OFFICE OF THE PRINCIPLE CHIEF CONSERVATOR OF FOREST, HOFF, RAJASTHAN, JAIPUR

CCF resubmitted the proposal after amendment corrections. User Agency submits digital maps of the proposal FP/RJ/Road/8746/2014 as per required by MOEF & CC for their letter no.8B/Raj/06/11/2015/FC/1467 dated 11.03.2016. After examination of digital maps some query in the submitted digital maps.

Sheet No 1

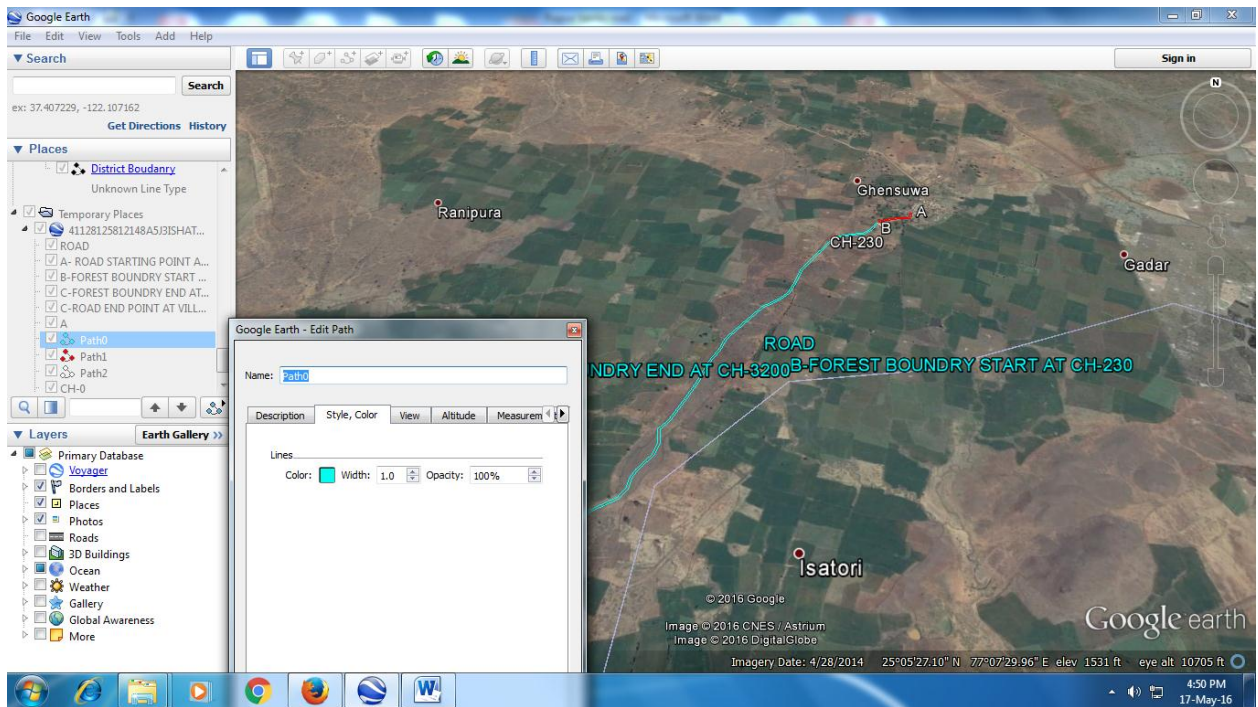
1. Digital Maps are in polyline shape while MOEF &CC required digital maps in polygon shape for DSS analysis.
2. Sheet No 1 expressed that provided digital maps are prepared in path. Total path are 3. One path are false.
3. Sheet no 2 expressed that provided digital maps are in line shape.
4. Sheet No 3 expressed that provided digital maps have a length of 5960 meter in forest while the length of road in forest is only 2970 meter.

Hence, Digital maps are not satisfactory, the proposal is to be forwarded to CCF for modify/ revised digital maps.
